April 12, 2013

**Re: *First Supplement to Major Comprehensive Plan Application –  
Salem Harbor Redevelopment (SHR) Project (Transmittal Number X254064)***

This first supplement to the Major Comprehensive Plan Application submitted on December 21, 2012 is being submitted on behalf of Footprint Power Salem Harbor Development LP (“Footprint”), and is based on comments provided by MassDEP in our meetings held in your offices on February 26, 2013 (for air quality related topics) and March 12, 2013 (for noise related topics). MassDEP requested that the following additional items be provided in a supplement to the Plan Application:

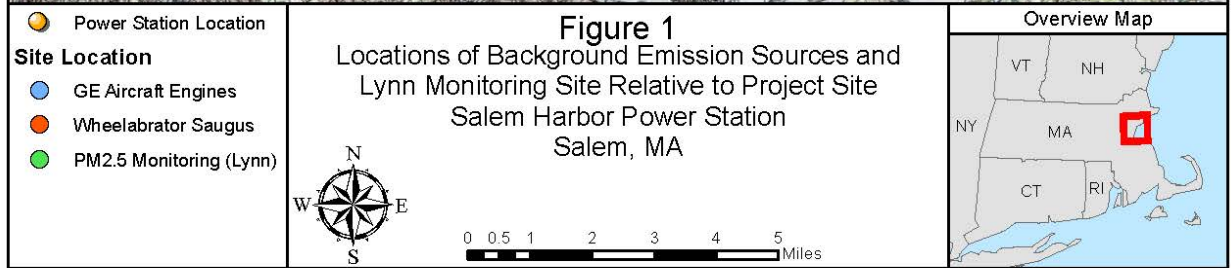
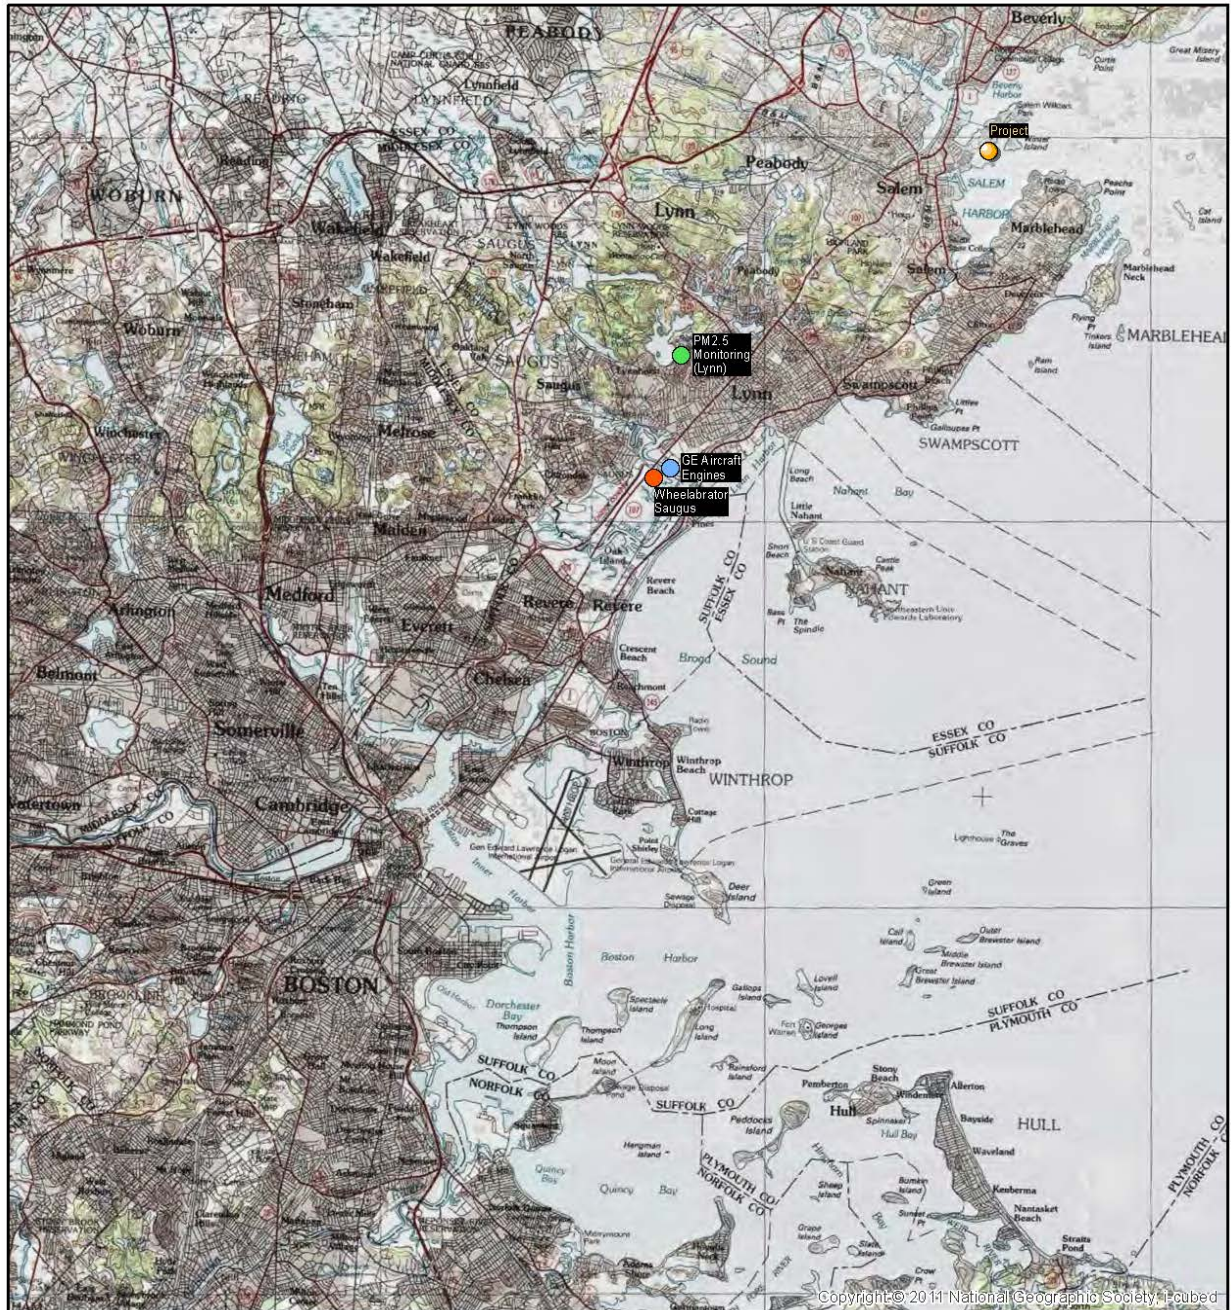
The relative location of the Project site to the Lynn monitor, the major sources modeled cumulatively, and the metropolitan Boston area is shown in Figure 1.

As noted in footnote 1 above, the Lynn monitoring site is located approximately 5.9 miles to the southwest of the project site. This monitoring site is representative of the Salem Project site since it is located relatively close to the site. However, use of data from the Lynn monitoring site is also conservative because Lynn is a more industrialized and densely populated area than the proposed project site area, particularly without the influence of the existing Salem Power Plant as will be the situation when the SHR Facility begins operations. The project site is located adjacent to Salem Harbor, a significantly large water body where potential emission sources are more limited. The Lynn monitoring site is also located closer to the metropolitan Boston area than the project site area. Any potentially elevated ambient background pollutant concentrations from emission sources located in and around the Boston metro area that may be transported to the Salem project area via predominant south southwesterly winds (winds blowing towards the north northeast), must pass the Lynn monitoring site, and are therefore represented in the measurement data collected at the Lynn monitoring site.

The GE Aircraft Engine facility in Lynn and the Wheelabrator Saugus waste-to-energy facility, which have been identified by MassDEP as the only two major industrial emission sources to be modeled cumulatively with the proposed SHR Facility, are located slightly less than 2 miles from the monitoring site but are located about 7 miles from the SHR Project site. Therefore, the cumulative modeling compliance demonstration, which includes both the background ambient concentrations and impacts from the interactive existing major sources potentially double counts the contribution of these sources and therefore, potentially overestimates cumulative impact concentrations. This is particularly significant because these two major sources are located to the south southwest of the monitoring site which means that they could potentially influence the monitoring site concentrations during south southwesterly winds (winds blowing towards the north northeast) which is one of the predominant wind directions in the area.
